工程指示 / 要求簡箋(E.I.)

工程指示編號：EI / 9760 / 18

工程名稱：觀塘裕民坊

工程項目：預留碼 E04 轉角款(加訂)(E04-60)

EMBED TYPE : E04

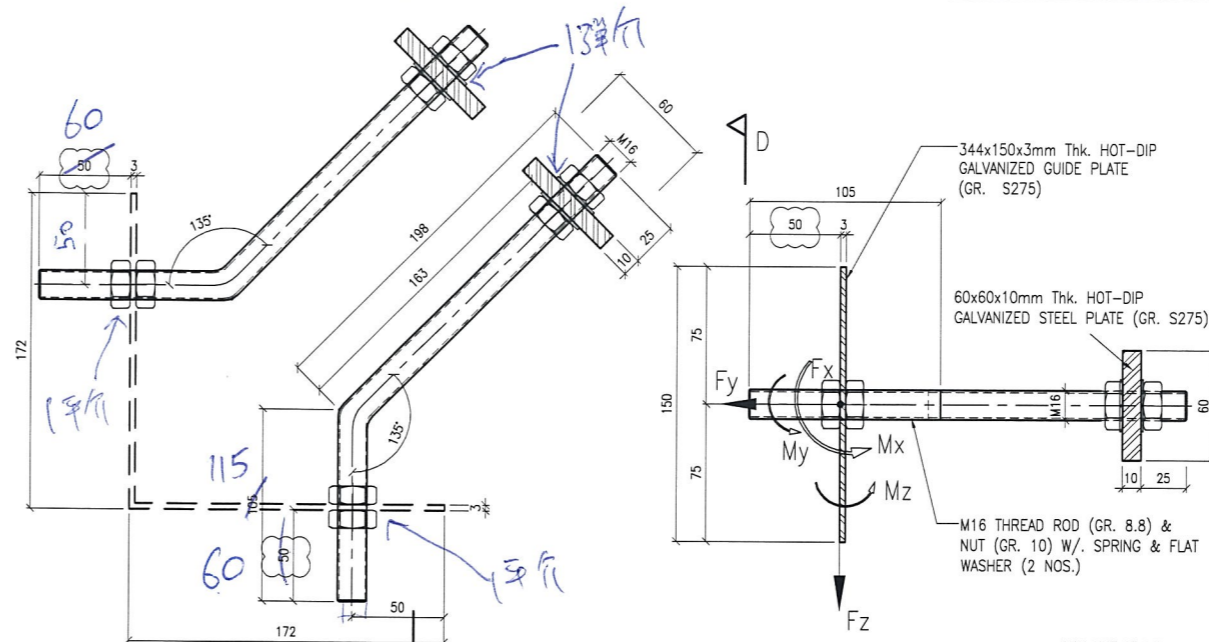
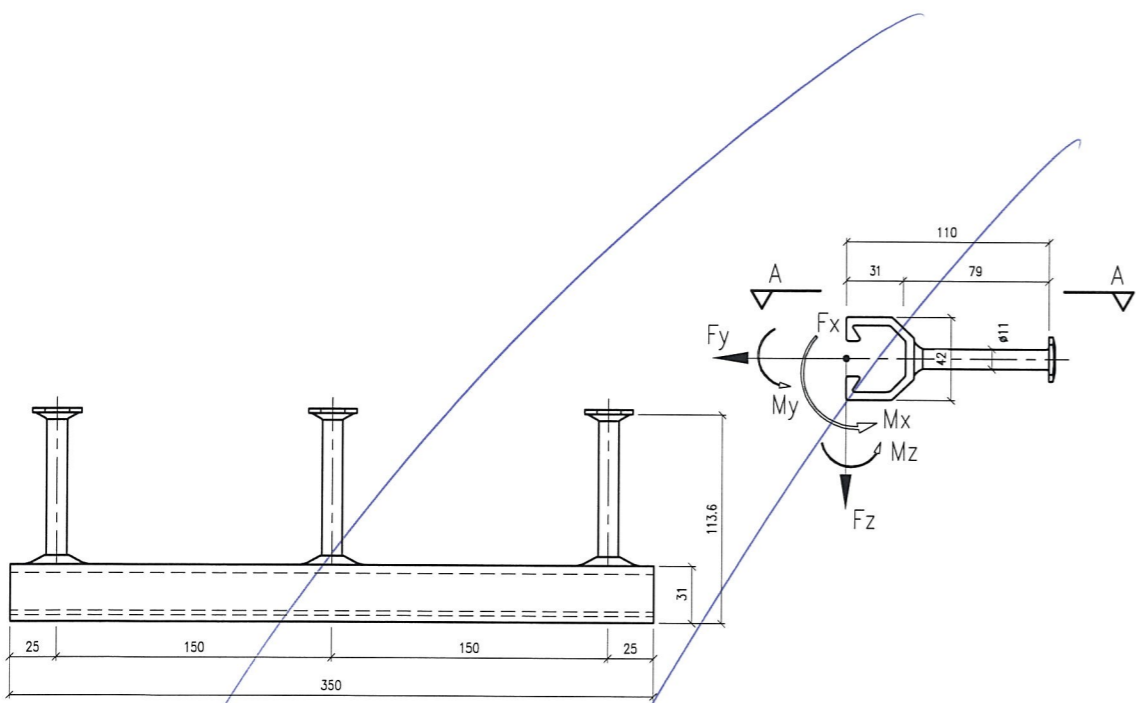
因 1st Shop Drawing 大圖畫錯，預留碼 Detail 與後頁 Detail 不符，
 E04 款預留碼修鋁介子後 有不足牙情況
 需按新尺寸重新加工 E04-60 款 (90 隻)

鐵介子, 螺母及平彈釘
 可用回 E04 款, 不用再訂
